Re: SES SOLAR TWO PROJECT (08-AFC-5)
CURE Data Requests, Set One (Nos. 1-143)

The Application for Certification
for the SES Solar Two Project

Docket No. 08-AFC-05

Figure 4. Recommend location of KOP and location of KOP# 5 (based on AFC Figure 3-10B).

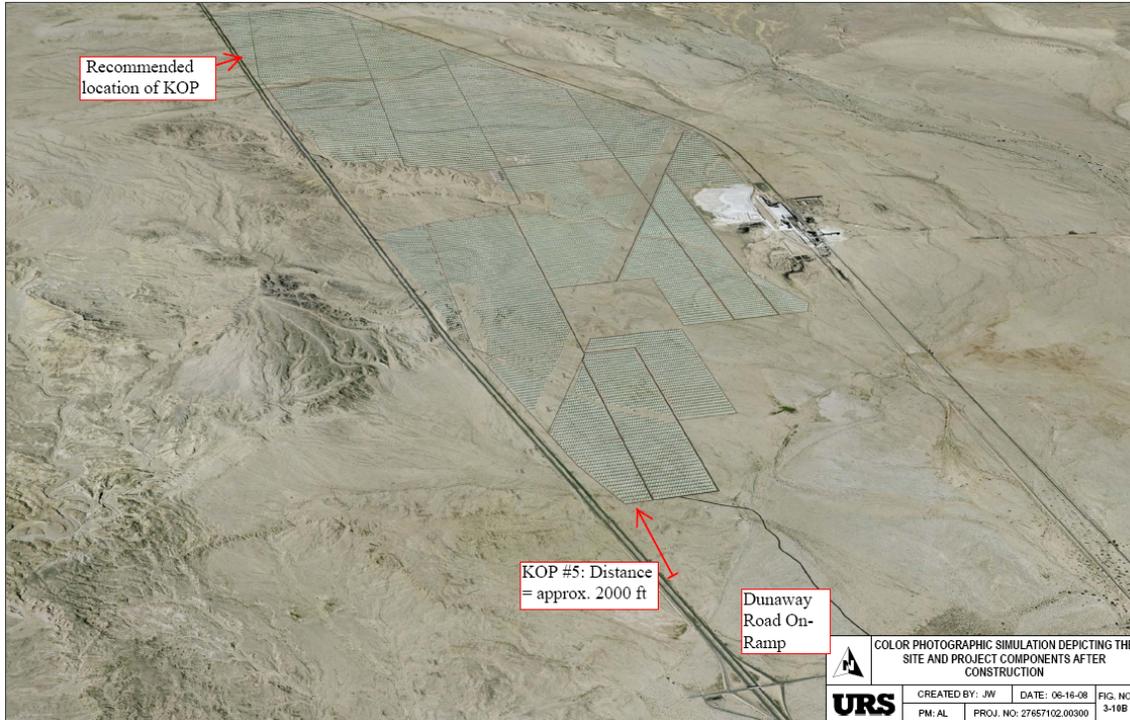
The simulated view at KOP #5 is not “immediately adjacent to the Project” as stated in the AFC (p. 5.13-29). The view from KOP #5 as measured on Figure 5.13-1 of the AFC is simulated from a vantage point located approximately 2000 feet to the east of the project site. We have prepared the figure below to depict the location of KOP #5. A location immediately adjacent to the project would be best represented from a location directly south of the Sun Catcher array as in the western portion of the project area where mirrors would be located within tens of feet from the Interstate 8 roadway (“recommended location”). We have reviewed the March 19, 2009 Draft Landscape Management Plan and have seen plans only for softening project features: no plans have been proposed to hide the solar array from passing motorists.¹⁰⁹

127. Please establish a key observation point directly south of the project near the western boundary where the mirror array will be closest to motorists and where, during mid-day low angle (winter) sun conditions, the potential for reflection and glint and glare would be greatest to passing motorists. Please provide simulations at the requested key observation point during different times of day and during different seasons to adequately predict impacts under a variety of conditions.

Figure 1. Site plan showing the location of the US Gypsum plant in relation to the SES Solar Two property (ESA Figure 2A).

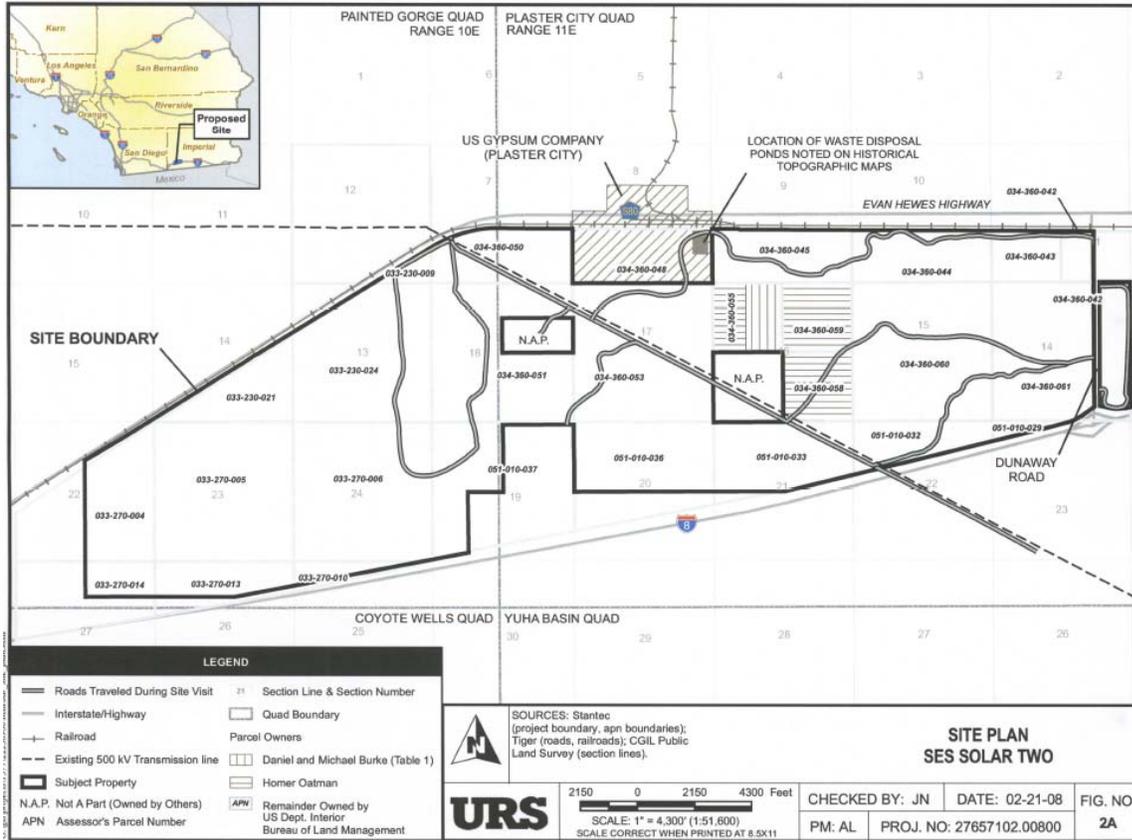
As shown in the figure below, the USG plant is actually bordered on three sides by the project site.

The AFC and supporting documents do not include a description of any further hazardous waste studies to have been conducted at the USG facility. The potential for contaminants to have flowed or blown onto the property may represent a potential health hazard for construction workers and for employees during operation of the project. Dust from the plant may affect operations of the SunCatchers.

140. Please provide all documents that may be available at regulatory agencies regarding the US Gypsum facility adjacent to the subject site that may include sampling data for soil, surface water and groundwater.
